# **FINAL SITE CLOSURE REPORT**

## **FORMER CONSTRUCTION DEBRIS LANDFILL #3**

**CAMP NAVAJO  
BELLEMONT, ARIZONA**

## Document: Draft VSI, FCDLF #3

**Figure 1-2**

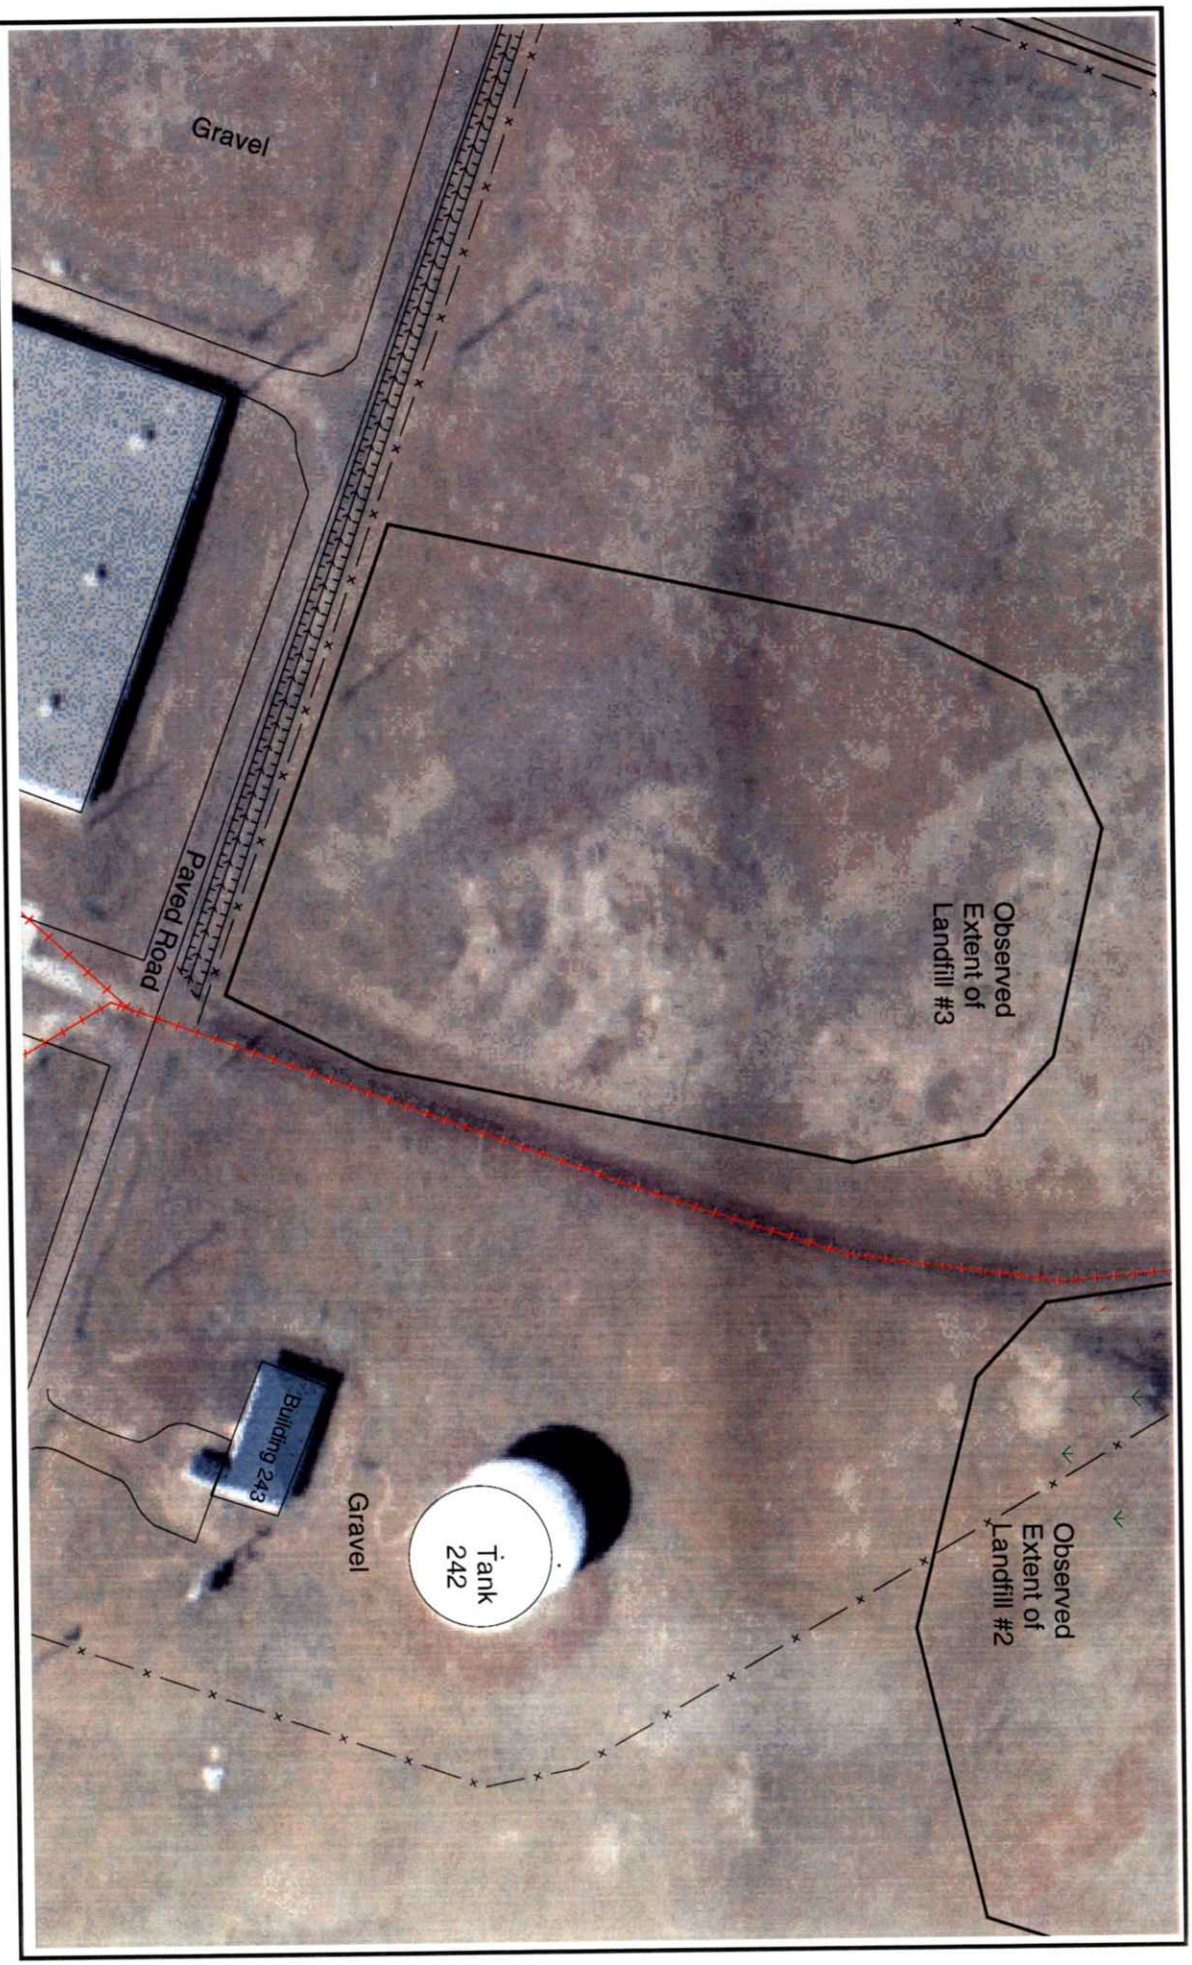
Figure 1-2  Indicate (arrow) site location	Will be revised in final.

**Figure 2-1**

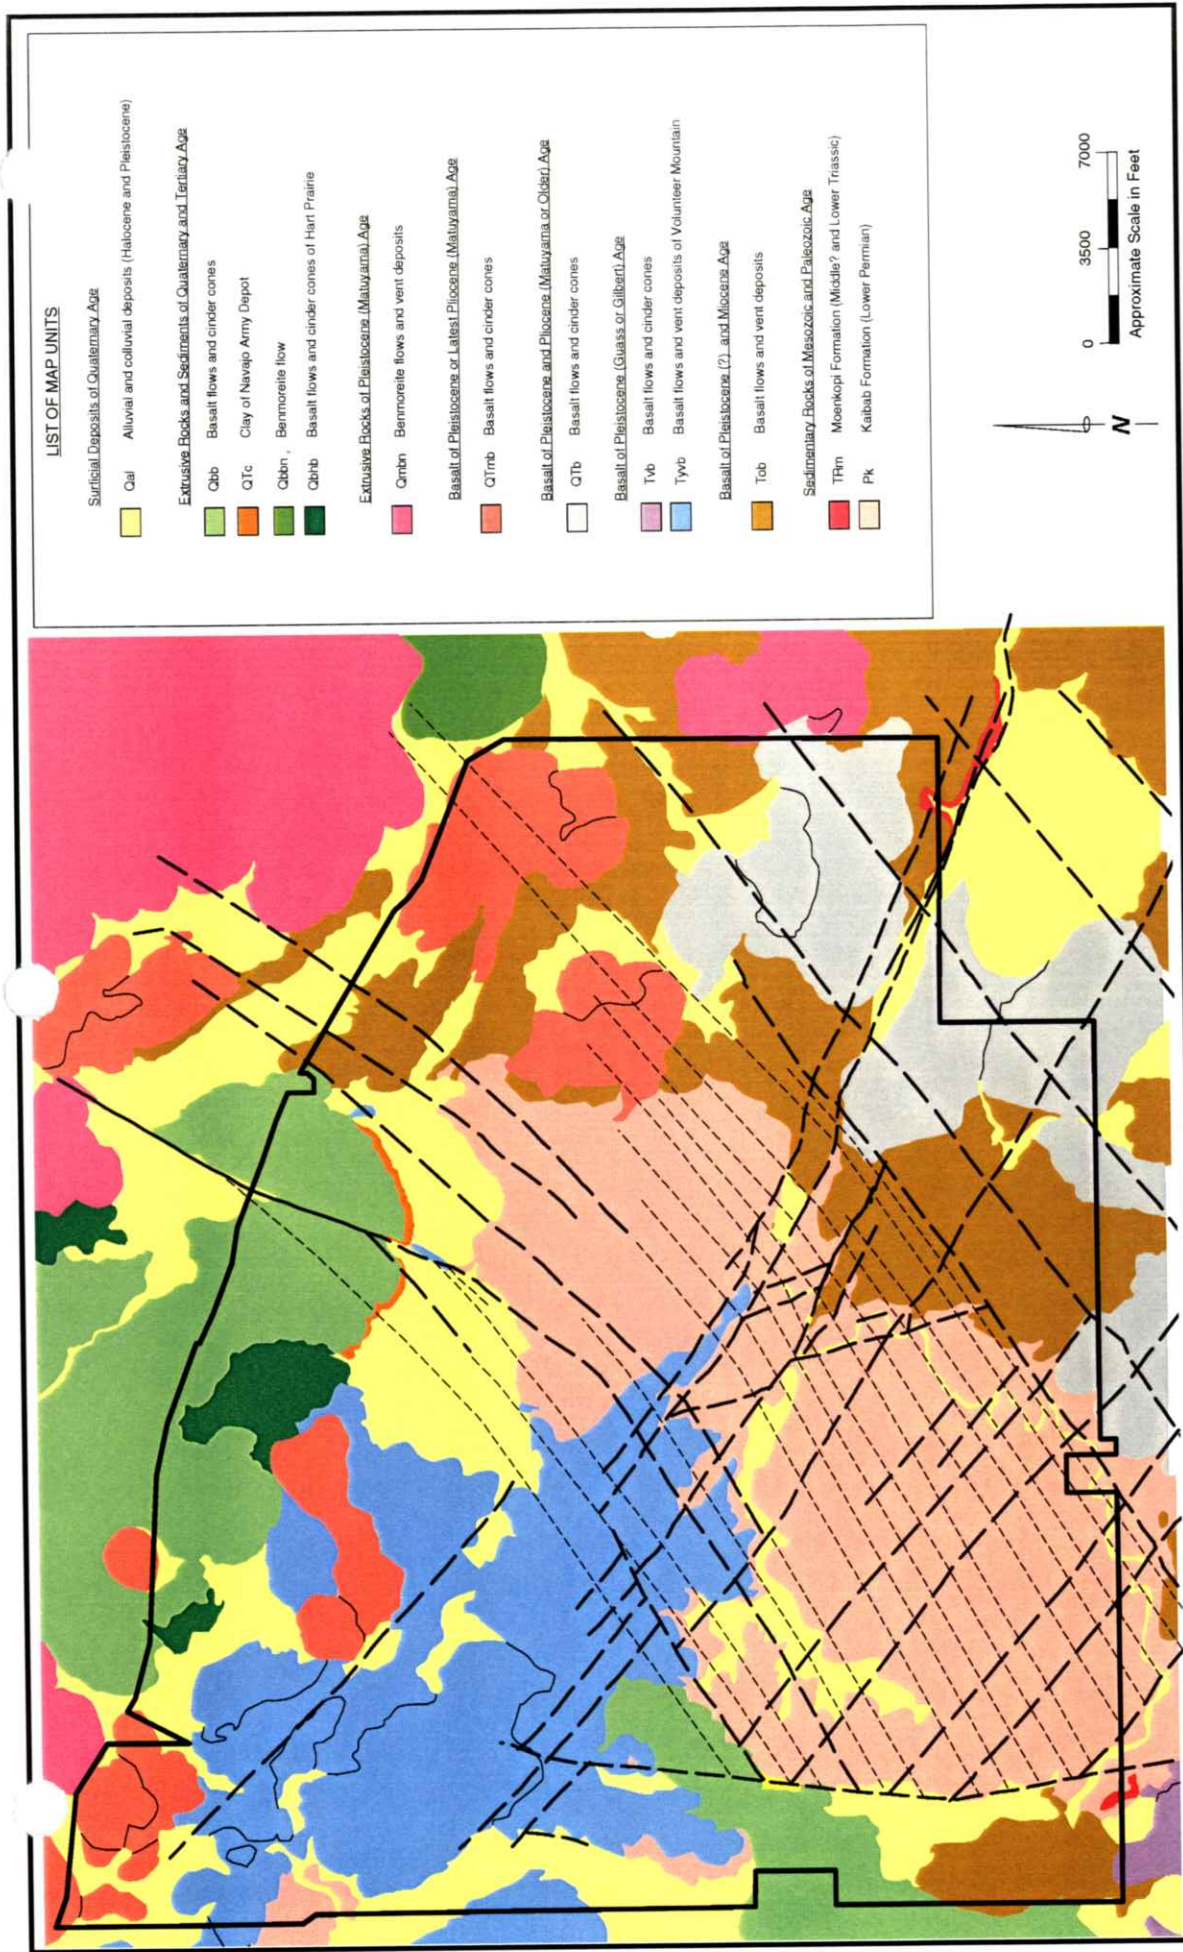
Comment	Response
Section 2.2. Figure 2-1; In the older February and March reports this map has one area of alluvium along the northern boundary that is shaded as basalt. In the newer November report two more areas (along eastern boundary and along Dunham fault) are incorrectly shaded. The blatant statement regarding faults as conduits on the older maps is made palatable by the addition of "potential" on the newer version, but would probably be best if deleted entirely. Also on the November report, the legend contains incorrect symbols for the railroad and suspected fault. Personally, I liked the geologically meaningful rock symbols of the older map better than the hatchured symbols of the newer map.	Figures in all closure reports will be revised to be clear and consistent.
Section 2.3. Paragraph 3; The water table is 200 feet below the top of the Supai Formation, and is not within the strata commonly assumed to be the aquifer in the Flagstaff area. Please revise this statement to reflect actual conditions below the Base. There is no justification for the statement regarding declining water levels. Only a handful of measurements exist, some of which are dubious. However, consider the following observations. Water levels since 1977 have remained higher than the 1369 feet measured then. Water levels measured during 1996 ranged from a low of 1343 (Tetra Tech) in January to a high of 1303 (USGS) in August, after a drought winter. Another 30 feet of rise is entirely conceivable in a wet year. Please remove your statement. See the comments for the Deep Well Report for further discussion.	Text will be revised in final.
